Re: Powertech (USA) Inc.'s Response to the Request for Additional Information to Support the Environmental Review of its Application for a Nuclear Regulatory Commission Uranium Recovery License for its Proposed Dewey-Burdock In Situ Leach Uranium Recovery Facility in the State of South Dakota  
Docket 040-09075, TAC No. J 00533

**Response to U.S. Nuclear Regulatory Commission  
Request for Additional Information  
Powertech (USA) Inc. Dewey-Burdock Project  
Environmental Review of Application for a U.S. Nuclear  
Regulatory Commission Source  
Material License**

**Response to the U.S. Nuclear Regulatory Commission's (NRC)  
Request for Additional Information for the  
Dewey-Burdock Uranium Project  
Environmental Report Submitted August 11, 2009.**

ER\_RAI Figure WR-3.1: Location of Confined Portion of the Fall River Aquifer

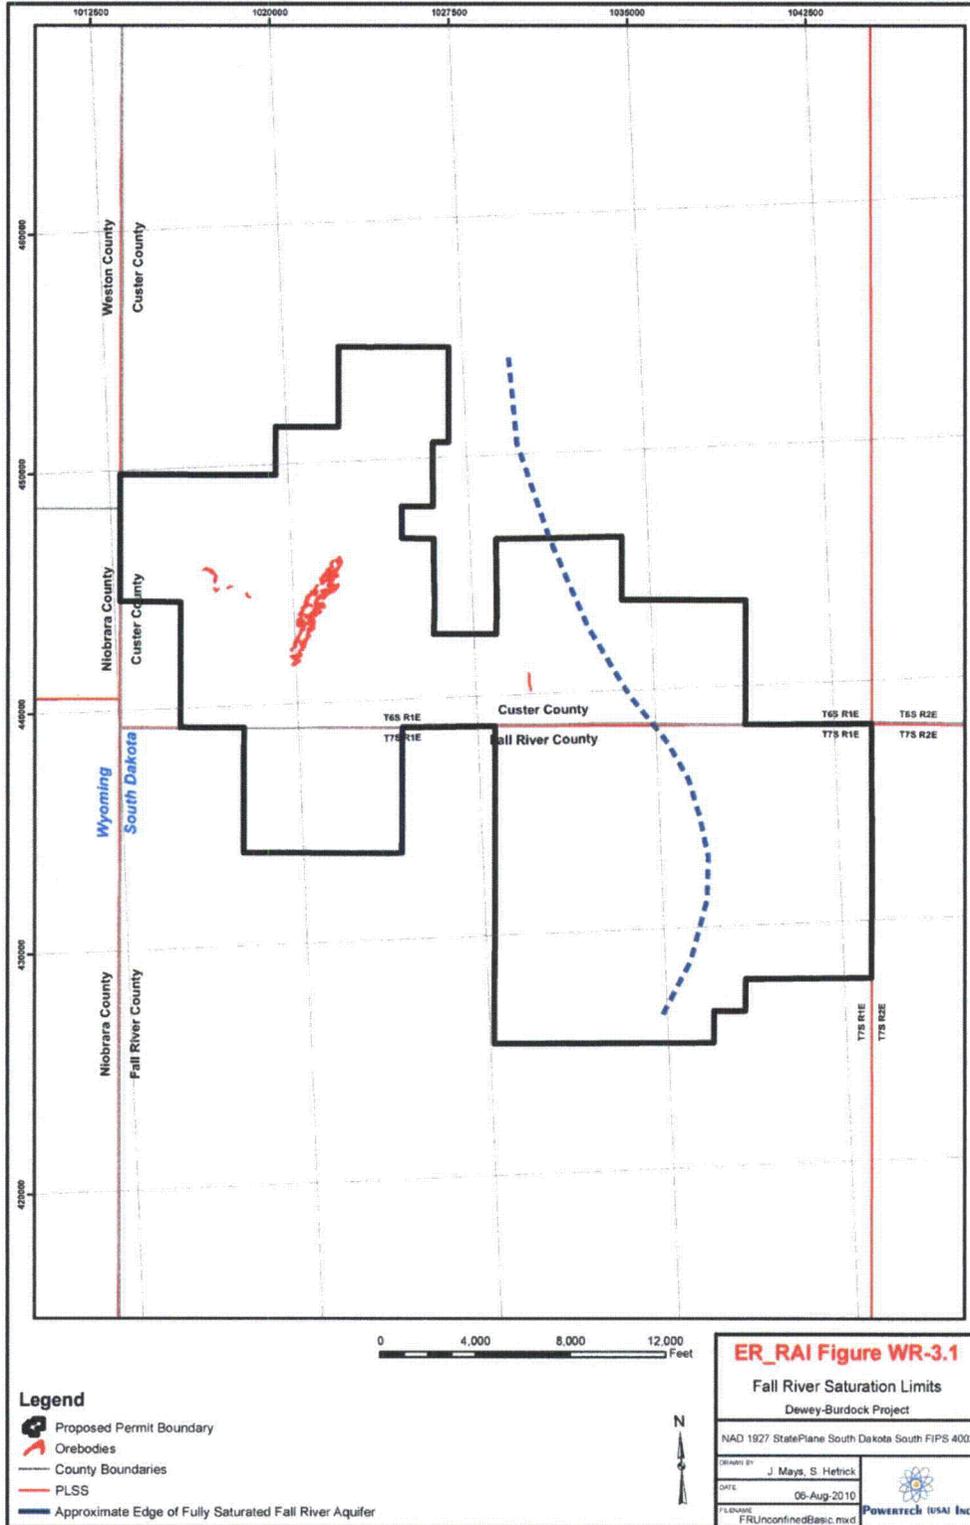
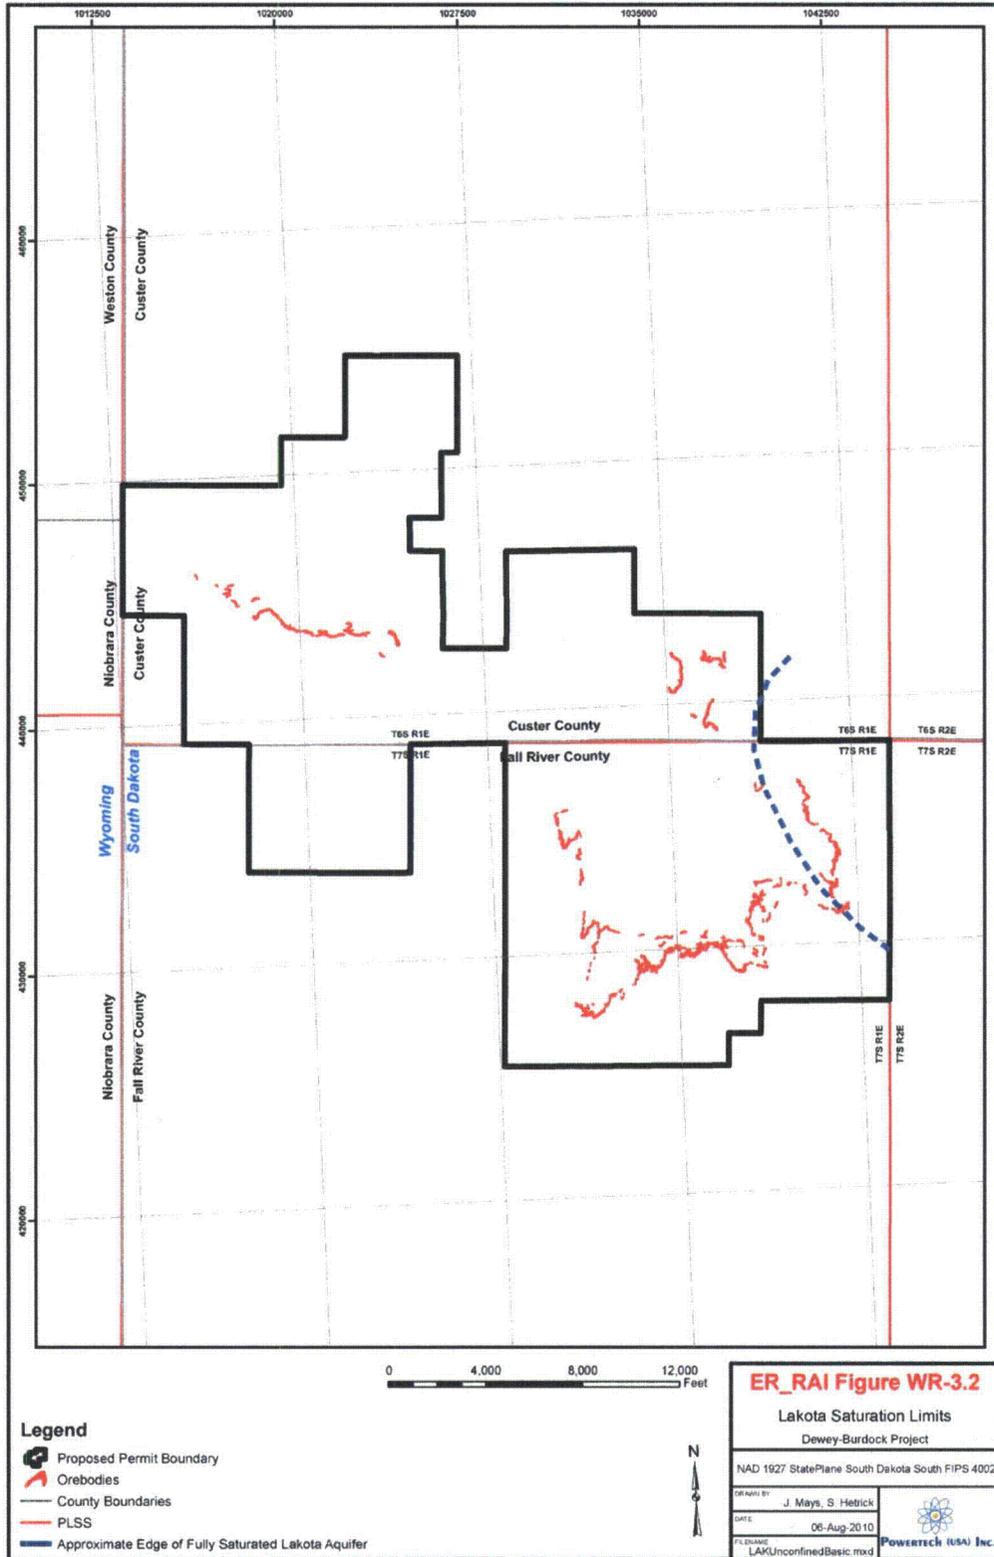
***Provide information on ISR operations in unconfined portions of the Lakota and Fall River aquifers in the Burdock portion of the project area.***

***1. Whether Powertech plans to conduct ISR operations in unconfined portions of the Lakota and Fall River aquifers in the Burdock area identified during delineation drilling and aquifer pump testing.***

***2. If the answer is yes to 1 above, information on well field design and construction and how Powertech plans to control and monitor production fluids in unconfined production zones.***

Proposed activities relative to estimated unconfined zones in the Fall River and Lakota aquifers are depicted in ER\_RAI Figure WR-3.1 and ER\_RAI Figure WR-3.2 respectively. The figures have a dashed-line estimating the approximate location at which each aquifer becomes saturated moving away from the outcrop where the potentiometric surface is at the same elevation as the top of the formation. The estimated boundary is approximated using the intersection of the potentiometric surfaces generated from water level measurements and the top structure contour of each respective aquifer and thus not highly accurate, and not confirmed with many data points. More precise measurement of the unconfined portions will be determined during an additional hydrogeological investigation prior to well field development. For the initially proposed well fields, Burdock Mine Unit I, and Dewey Mine Unit I, conditions are well confined with water levels several hundred feet above the top of each aquifer and confined conditions measured in aquifer pump tests.

Powertech (USA) plans for ISL operations within potentially unconfined portions are limited to the eastern side of the project in portions of Burdock Mine Unit II and Burdock Mine Unit IV in the Lakota Formation. Though ore bodies are present in unconfined portions of the Fall River formation on the eastern side of the permit area, Powertech (USA) does not propose to mine in those Fall River ore bodies in this license application. Furthermore, Powertech (USA) has limited its proposed operations in the Fall River Formation to the Dewey portion of the project. **Supplement Exhibit 3.1-4 Revised** "Future Mine Units" depicts ore bodies which Powertech (USA) plans to mine in the project.

ER\_RAI Figure WR-5.1: Distribution of Water Rights within the Madison Aquifer.

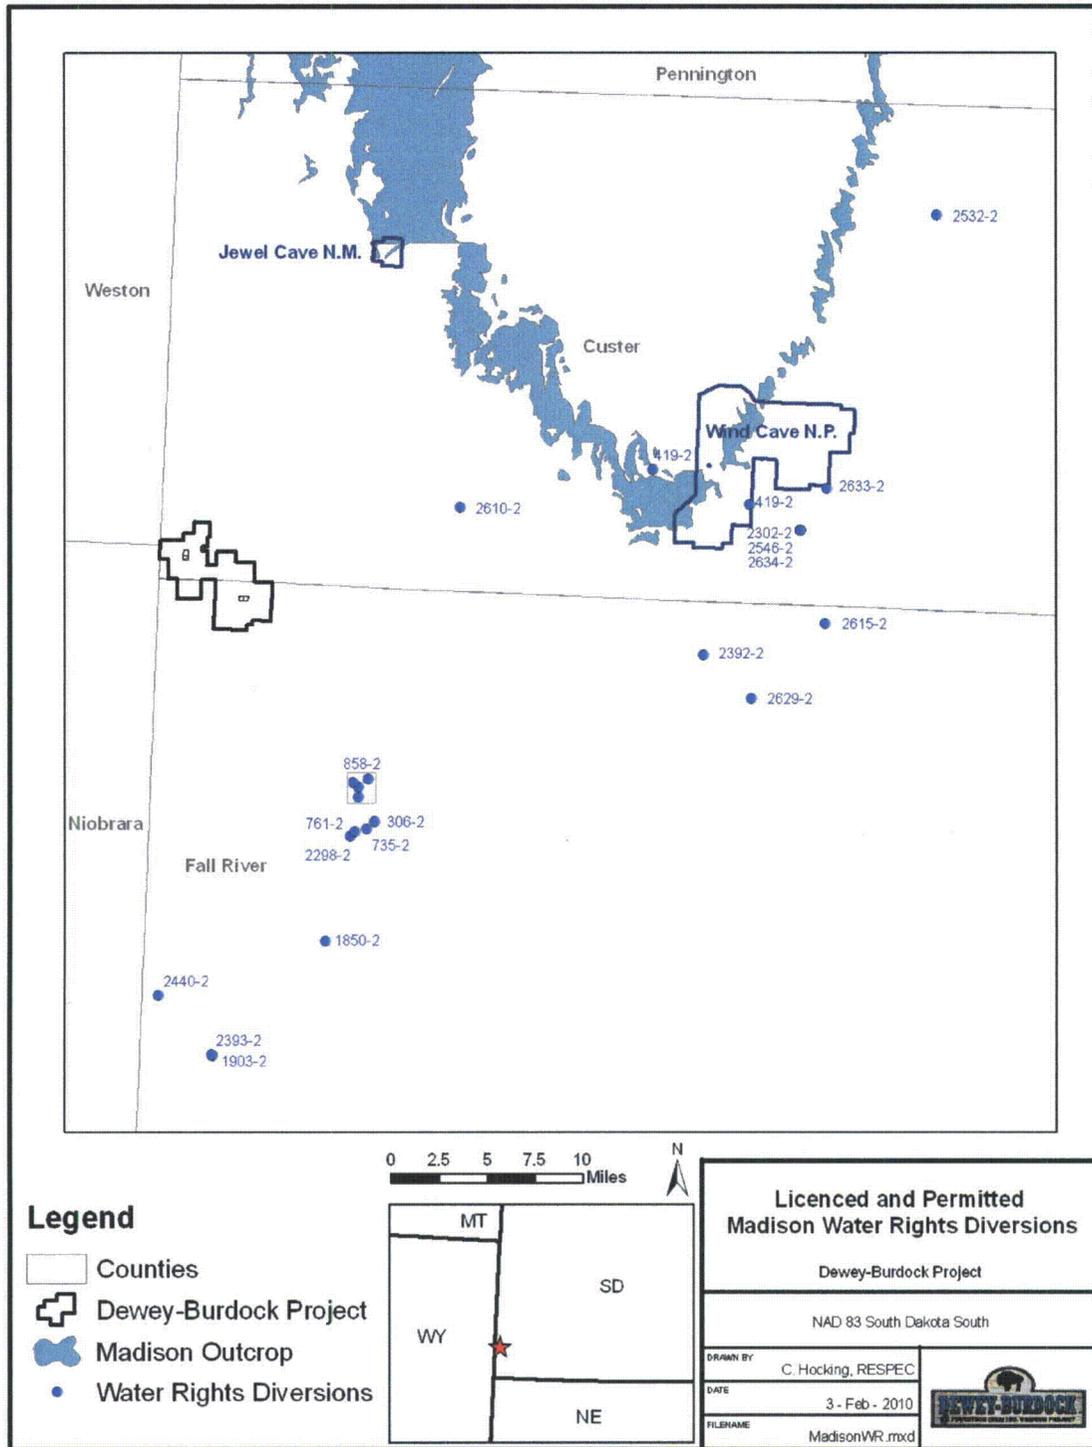
***Provide information on the status of obtaining water appropriation permits for use of water from the Madison aquifer.***

- 1. Please provide information on the status of obtaining a water appropriation for use of Madison aquifer water during operations and aquifer restoration.*
- 2. If water rights permit cannot be secured for the Madison aquifer provide information on the potential alternatives to meet water requirements during operations and aquifer restoration and how each alternative would impact groundwater levels, flow rates, and flow directions.*

The water rights application is planned to be submitted to DENR during 2010. There is currently limited use of the Madison water within the immediate vicinity of the project area and sufficient availability to meet the needs of the project. There are no reasons to expect that the permit would not be accepted and it is believed that the proposed project meets all acceptable criteria for obtaining a permit.

**Figure SOC-1.1: Unemployment Rates, Wyoming, 2000 – 2009**

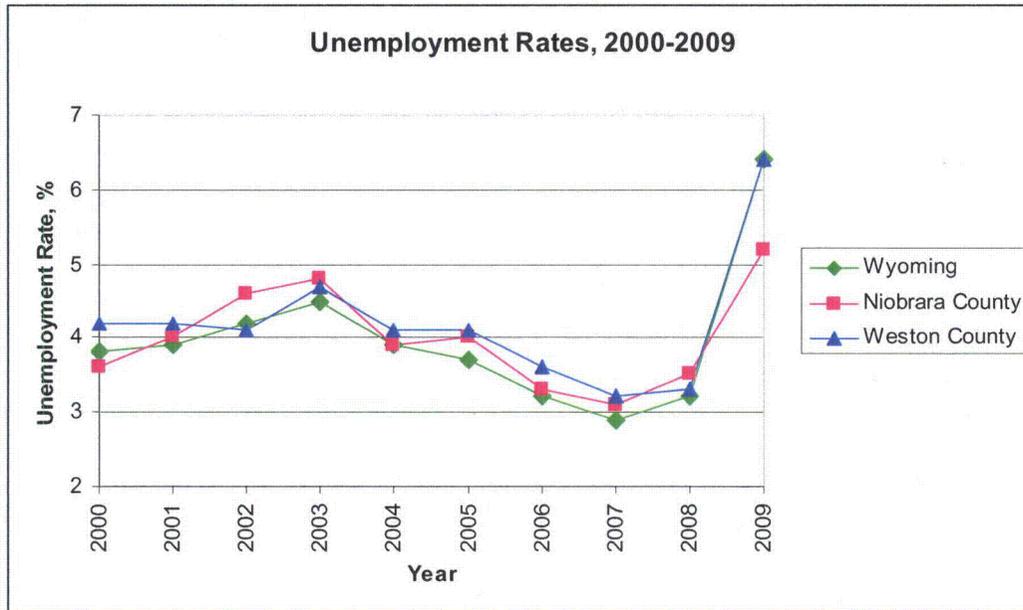
- 2. Provide annual average labor, employment, and income characteristics for direct social zones within the region of interest for Wyoming, similar to data provided in ER Section 3.10.3 for South Dakota.*

Unemployment trends for Niobrara and Weston Counties and Wyoming's state-wide rate over the last decade are presented in **Figure SOC-1.1**, which plots the average unemployment rate for each year determined from monthly county and state data provided by the WDE's Local Area Unemployment Statistics (LAUS).

As the figure shows, the average unemployment rates have remained similar between the Counties of Niobrara and Weston and the State of Wyoming. No major disparities between county and state trends have occurred in the last decade.
